14 CFR Part 39

[Docket No. 83-ASW-38; Amdt. 39-6686]

Airworthiness Directives; Enstrom Helicopter Model F-28A, F-28C, F-28C-2, F-28F, 280, 280C, and 280F Series Helicopters

ACTION: Final rule.

Figure 1. Checking inner spline wear on coupling.

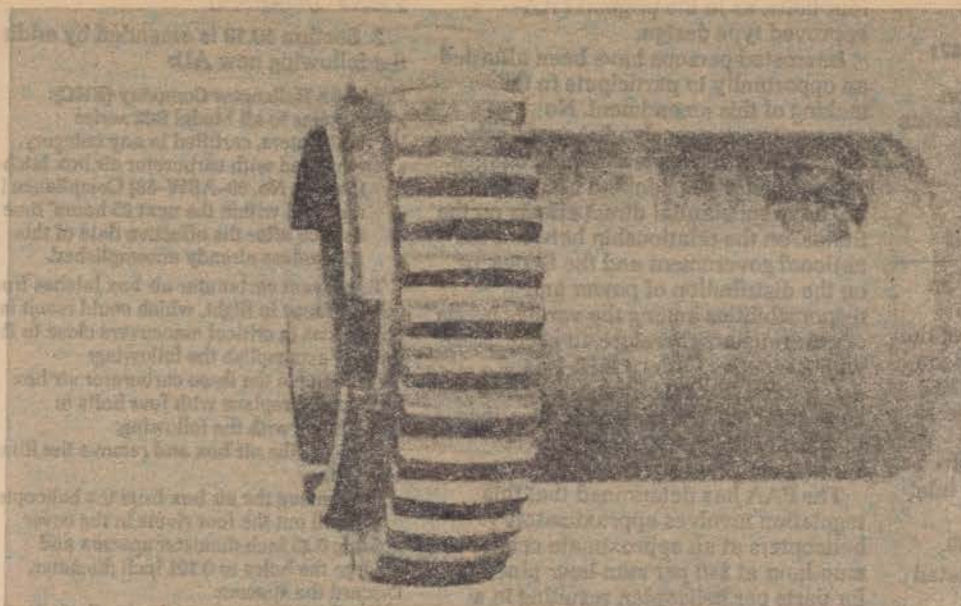
(i) Visually and dimensionally inspect for wear and proper tooth contact in accordance with Figure 1. Measure the height of the spline crown shown in Figure 2 at the center with a steel scale (having graduations of 1/100 inch) and a 10 power glass. Replace with airworthy parts and couplings that have a center crown height of less than 0.015 inch.

NOTE: Tooth wear is measured by placing a 6 inch steel rule parallel to the crown at the top edge of the driven side. A piece of .125 x .010 inch shim stock is then placed between the tooth and the rule, and pressing the rule against the tooth, check if the shim can be removed. If the shim slips out, the coupling is to be rejected and replaced with an airworthy component.

FIGURE 1

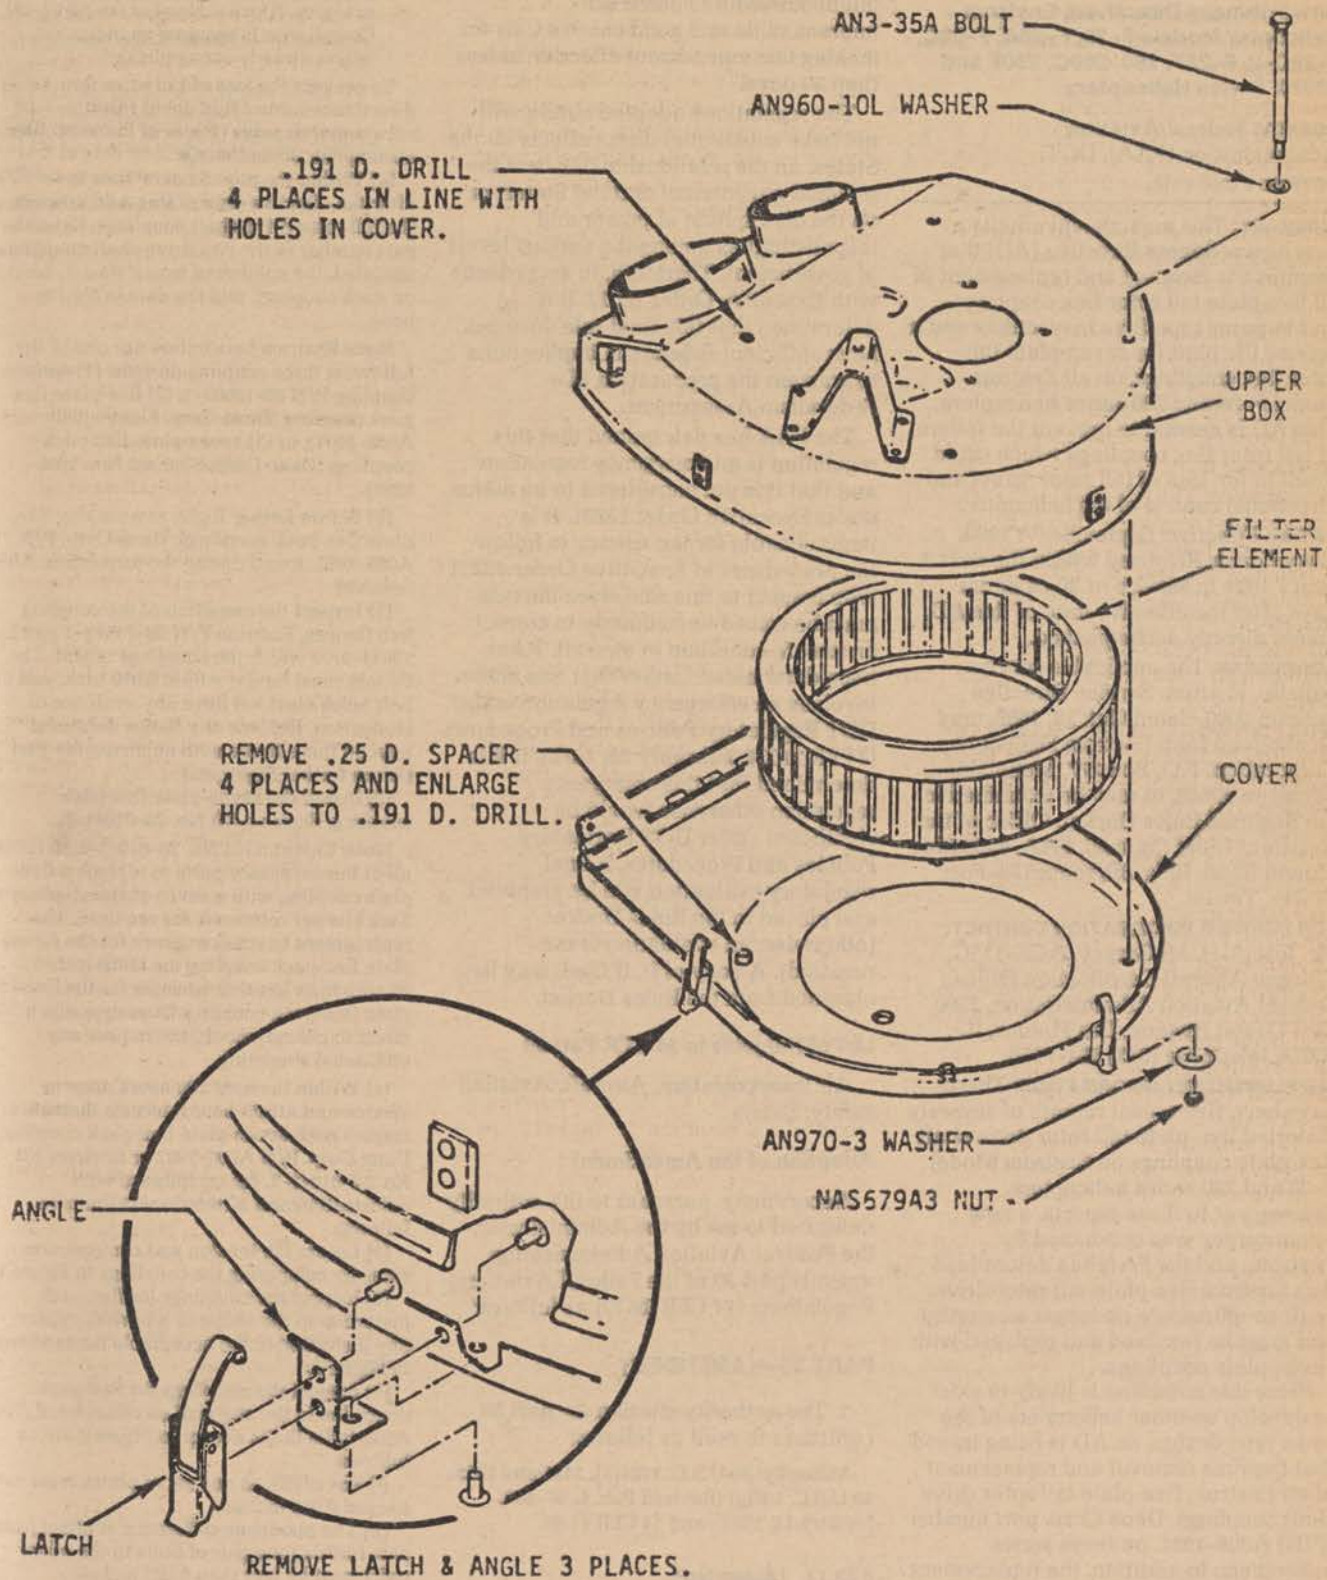
- (a) Remove the three carburetor air box latches and replace with four bolts in accordance with the following:
 - (1) Open the air box and remove the filter element.
 - (2) Remove the air box from the helicopter.
 - (3) Drill out the four rivets in the cover holding 0.25 inch diameter spacers and enlarge the holes to 0.191 inch diameter. Discard the spacers.
 - (4) Close the cover, and using the holes in the cover as guides, drill four matching holes through the upper box in line with the holes in the cover.
 - (5) Open the air box and drill out all the rivets holding the latches to the cover. Discard the latches and angles. Clean the drilling chips from the box.
 - (6) Reinstall the air box to the helicopter.
 - (7) Install the filter element and secure the cover using four AN3-35A bolts, AN960-10L washers, AN970-3 washers, and NAS679A3 nuts.

Note: Refer to Figure 1 for accomplishing the instructions required by paragraph (a).
